Subject: DRS/Spec Big Hit Comp - '04

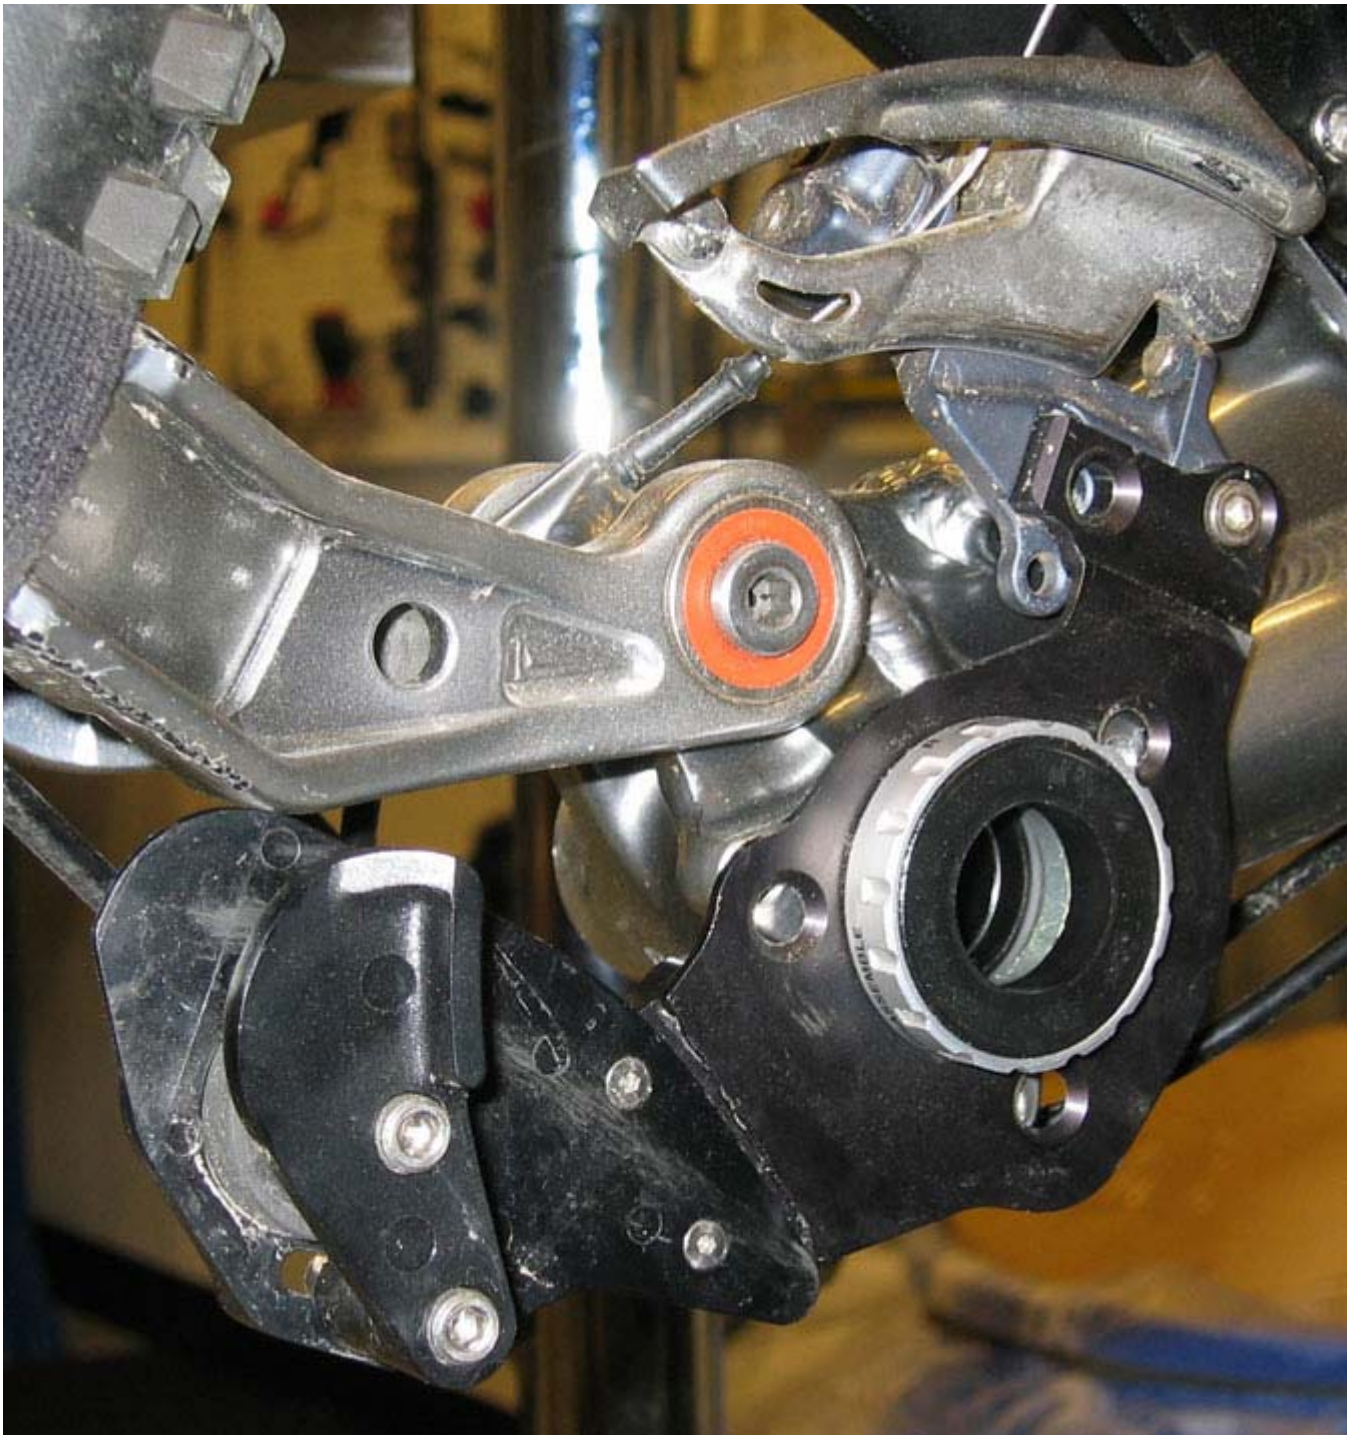
First, the problems with mounting the guide directly to the ISCG mounts.

As you can see in the picture BBSHell.jpg, the flange for the ISCG tabs are recessed from the outer edge of the bottom bracket shell. I didn't measure exactly how far, but in order to use them, you'd have to find washers that are the exact thickness needed to space the DRS out and keep it from warping when you tighten these and the bottom bracket cup down. Also, with how heavy duty the e-type wing on the backing plate is, the derailleur is spaced too far to the non-drive side of the bike by about a millimeter to clear the post sticking off the frame. Beside all of that, the ISCG tabs are rotated too far clockwise, so that if the derailleur is in the lowest position, you only have about a millimeter of clearance between the stop screws and the "black" link for the rear suspension, when the link is set up in the highest position. The BigHit has the benefit of adjustable BB height and head angle, and these are achieved by using one of 4 lower shock positions in the "black" link of the rear suspension. If you set the bike up with the steeper head angle (also higher bottom bracket), it moves the linkage down a fair bit, and this would easily contact the front derailleur. The lower rub plate on the DRS contacts the chain stay as well. Clearance.jpg shows how close the stop screws get to the linkage, and DRS2.jpg shows the wear plate hitting the chain stay. You could trim the wear plate, I'm pretty sure with no ill effects, but you'd still have the problems of the stop screws and not being able to use the steeper head angle suspension settings.

To overcome these issues I used a 1.5mm thick spacer between the DRS back plate and BB shell to make the derailleur clear the locating post on the frame, and use the derailleur locating post itself to keep the DRS from twisting around the bottom bracket. The post I speak of is in the pic BBSHELL.jpg. It seems sturdy enough for this job, but time will tell.

Drs3.jpg shows the backing plate how it should be setup with this method - also shows how far off the ISCG tabs are.

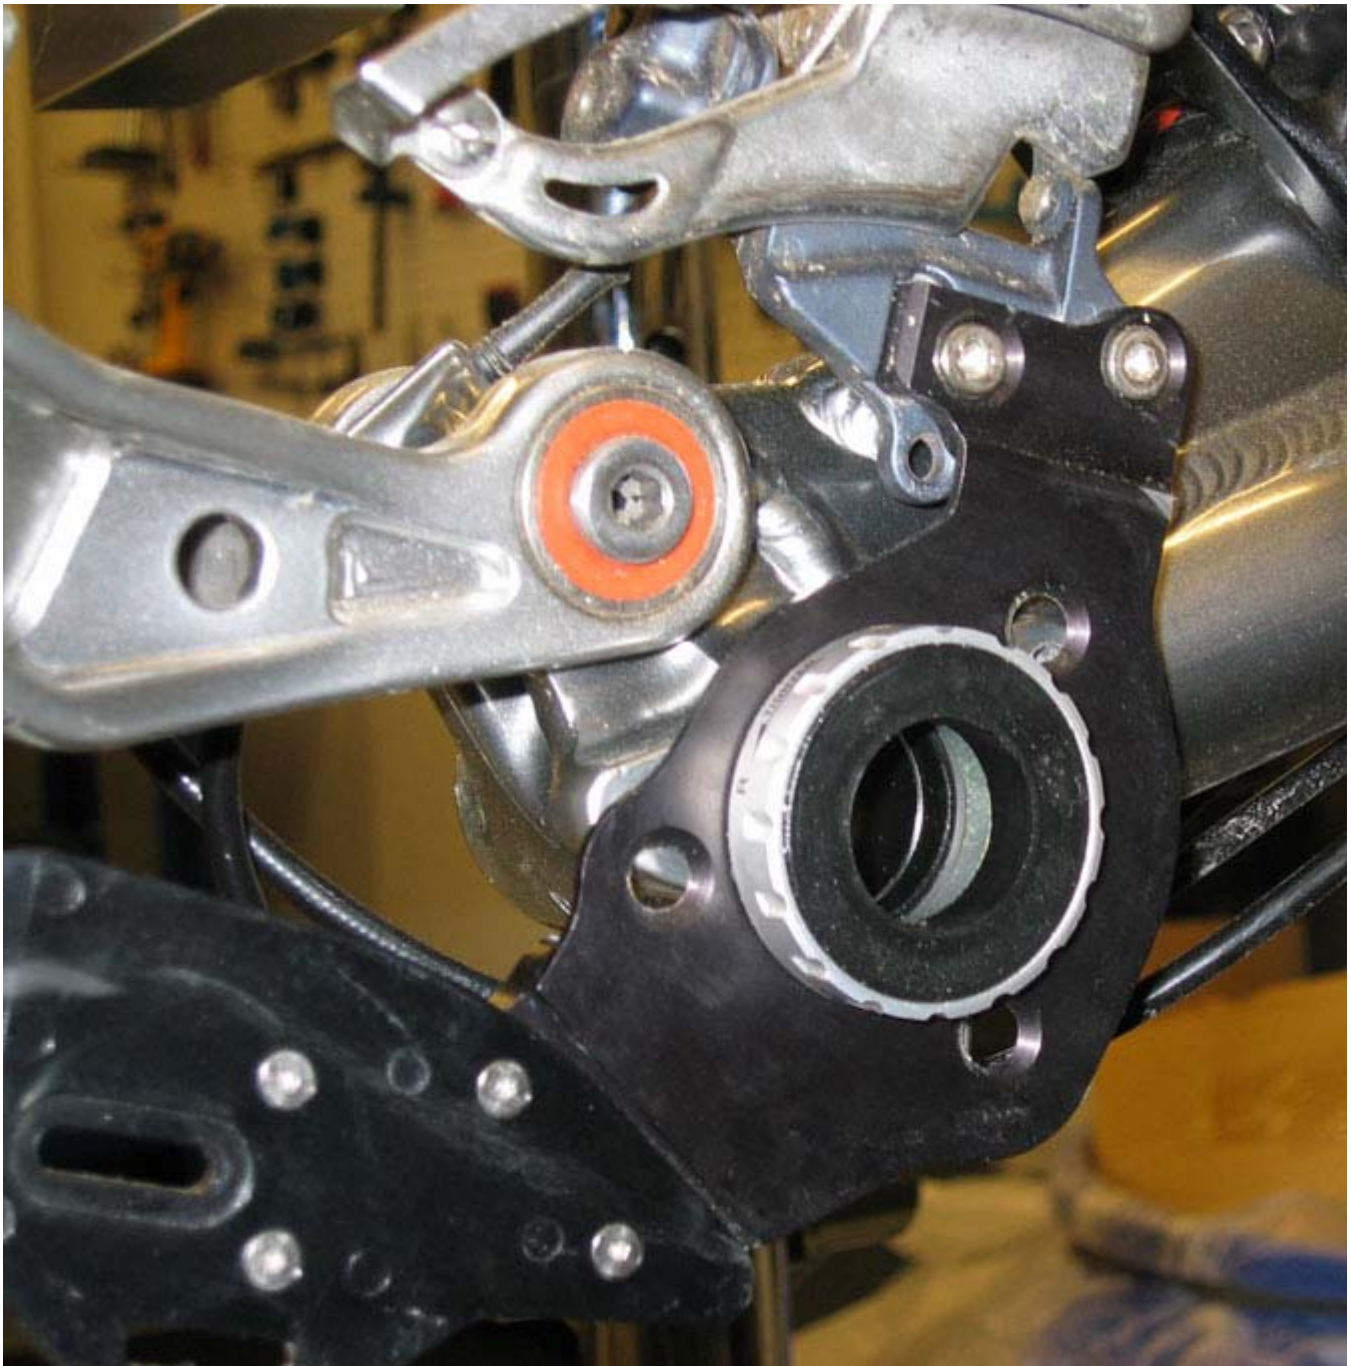
This puts the derailleur in the exact same position it is on the bike from the factory, as well as giving adequate clearance between the wear plate and the chain stay. People will probably need to keep the derailleur in the lower position to maintain the clearance from the black link. The chain rubs heavily on the bottom part of the derailleur cage from the factory anyway, and doesn't need to be moved up at all, even with my 26/36 setup.
